SECTION 6. COMBINATION TRANSMITTING AND RECEIVING EQUIPMENT

MODEL MN SERIES TROUBLE SHOOTING NOTES

FIGURE 1.—Schematic of preselector for model MR radiophone.

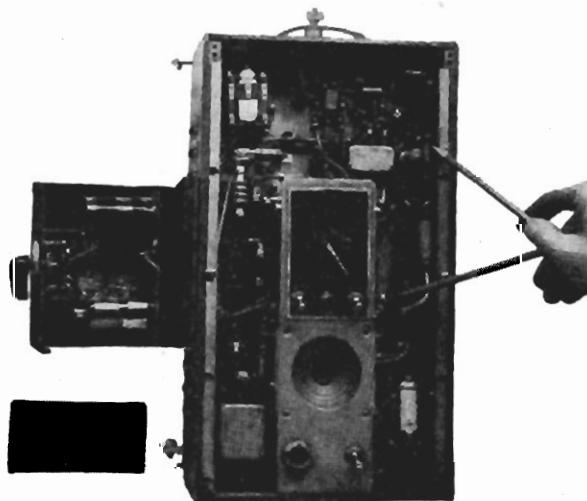
suitable preselector which prevents radiation of the local oscillator. When the preselector is incorporated in the equipment, the model MR may be used aboard ship. Figure 1 is the schematic diagram of the preselector. Figures 2 through 5 inclusive show constructional views of the preselector.

Switch S-1 provides for switching for the four fixed channels. The tuning condensers C-1, C-2, C-3, and C-4 are tuned on switch positions 1, 2, 3, and 4 respectively for any frequency in the range of the equipment. The tuning condensers have been so connected that the tuning of each channel is independent of all others. Adjustment

FIGURE 2.—Revised socket connections.

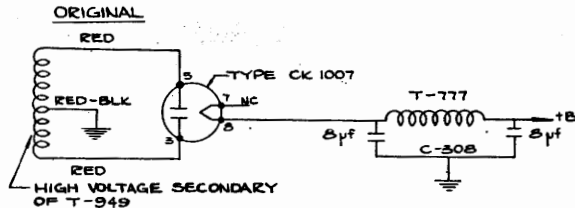
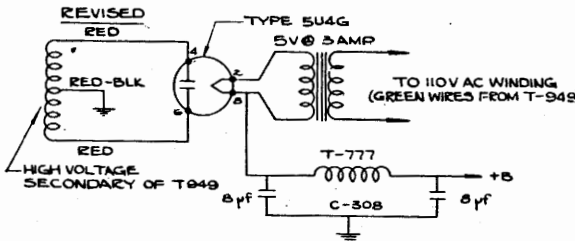
The operation of the equipment may be improved by substituting a type 5U4G rectifier tube for the CK 1007 tube. Power is supplied to the filament of the 5U4G from a 110- to 5-volt step-down filament transformer. The secondary of the transformer should be capable of supplying 3 amperes continuously. Use of the 5U4G tube will require rearranging the socket connections as shown in Figures 1 and 2. Socket pin connections for the 5U4G are shown in Figure 3.

FIGURE 1.—Method of mounting a type MP-37 whip assembly on an MAM equipment.

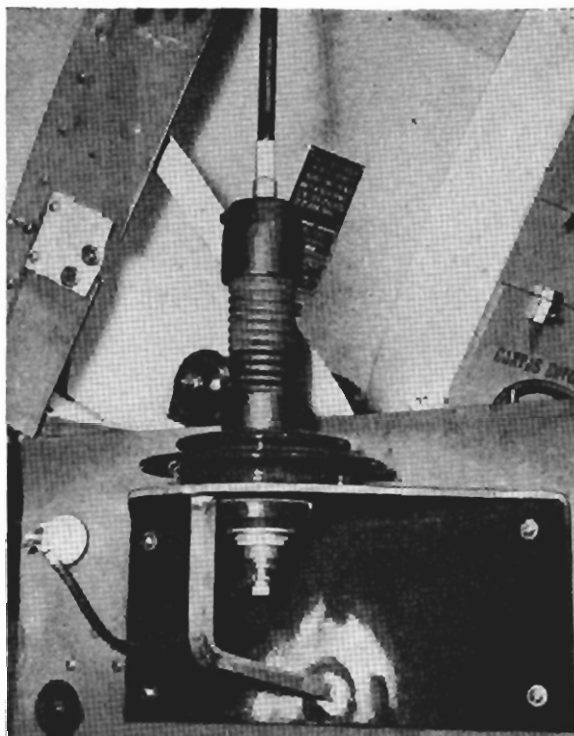
Experiments indicate that by supplanting the whip antenna furnished with a type BG-56A whip, or equivalent, the needed performance is obtained without interfering with other equipments at adjacent fields.

The photograph of Figure 1 shows a close-up of the method employed in mounting a complete type MP-37 whip assembly, including the spring base employed to prevent the whip from snapping off.

FIGURE 1.—Details of the transformer and interconnections needed for the modification.

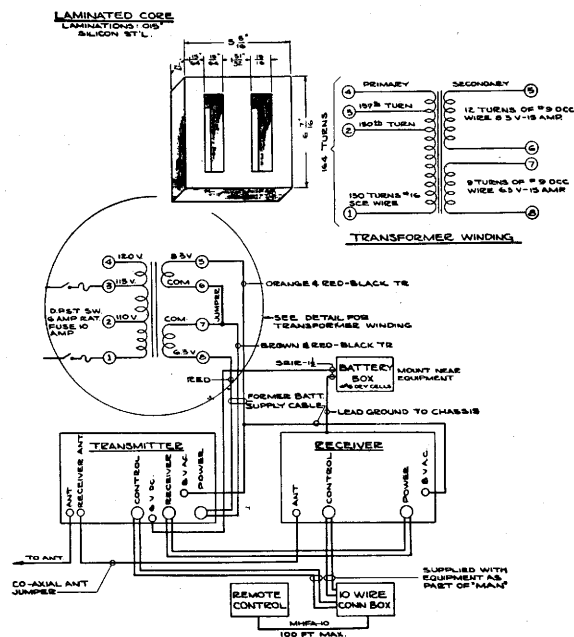
A 10-wire connection box must be mounted within 3 feet of the transmitter and receiver (see Fig. 1). This connection box is to splice

the leads coming from the MAN equipment and the remote head if one is used. When wiring the remote, note that the numbers attached to the wires from the equipment correspond to numbers on the terminal board in the remote control head. Do not connect wire #1 to pin #1 on the plug, that is, pins on plugs do not correspond to numbers taped on wires.

FIGURE 2.—FMT-25VW transmitter vibrator power unit modification.

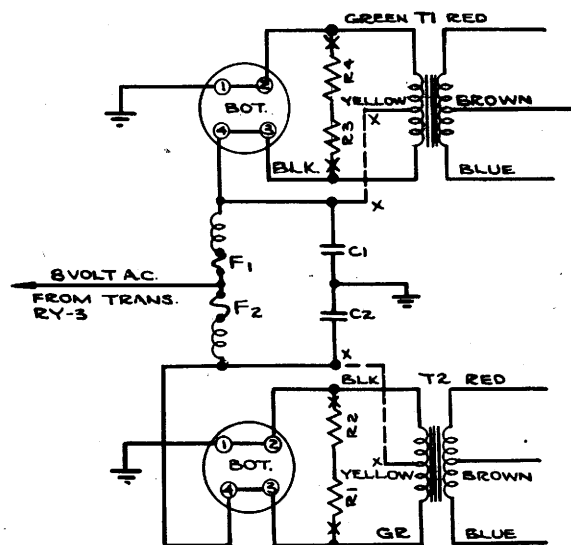
The following changes are made to the transmitter vibrator power unit, as shown in Figure 2:

- (1) Remove vibrators.
- (2) Remove R_1 , R_2 , R_3 , and R_4 .
- (3) Connect jumpers from pin #1 to pin #2, and from pin #3 to pin #4 on both vibrator sockets.

- (4) Disconnect the center tap of power transformer T-1 (two solid wires in yellow spaghetti). Solder together the two wires and tape up to insulate from the chassis. This connects the two halves of the primary in series. Power transformer T-2 is modified in the same manner.

- (5) Disconnect and tape 6-volt power supply lead (copper rope). Run new lead from this point to 8-volt a-c supply.

- (6) Replace 50-amp. main power fuse with a 15-amp. fuse.

- (7) Replace 20-amp. receiver fuse with a 10-amp. fuse.

FIGURE 3.—FMR-13V receiver vibrator power unit modification.

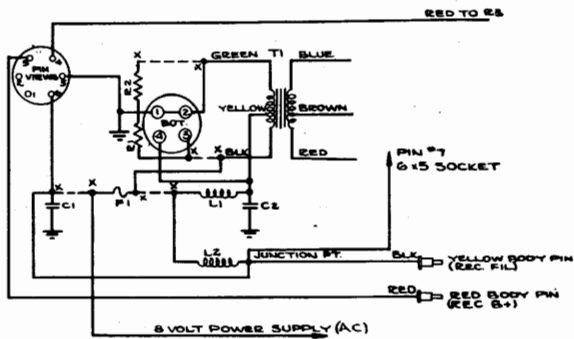
The following changes are made to the receiver vibrator power unit, as shown in Figure 3:

- (1) Remove vibrators.
- (2) Remove R_1 and R_2 .
- (3) Disconnect and solder together center-tap leads (yellow) on primary of T₁.
- (4) Connect pins #1 and #2 on vibrator socket together.

(5) Remove wires as indicated by dotted lines and "X".

(6) Connect 8-volt a-c supply to F_1 ; remove black wire coming from transformer primary from vibrator pin #3, and connect it to remaining side of F_1 .

(7) Run jumper, from the junction of pin #7 of 6X5 socket and yellow pin connector, to pin #6 of power plug.

(8) Rec. tube 6K6 by-pass condenser C-73 is changed from 0.02 to 0.002 mfd.

FIGURE 4.—Transmitter terminal strip modification.

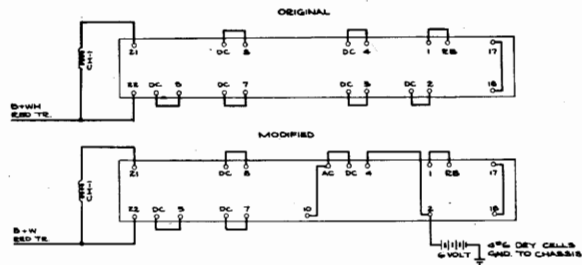
The following changes are made at the transmitter terminal strip, as shown in Figure 4:

(1) Remove jumper between DC and 4. Connect DC to AC. Extend jumper to lug 10.

(2) Connect lug 4 to lug 2.

(3) Make up pair 24-inch leads. Connect one to lug 2, other to chassis. Connect free ends to 6-volt battery, made up of four no. 6 dry cells in series—dry cells to be placed in compartments inside equipment case.

(4) Remove jumpers between lugs DC to 3, and DC to 2. ←
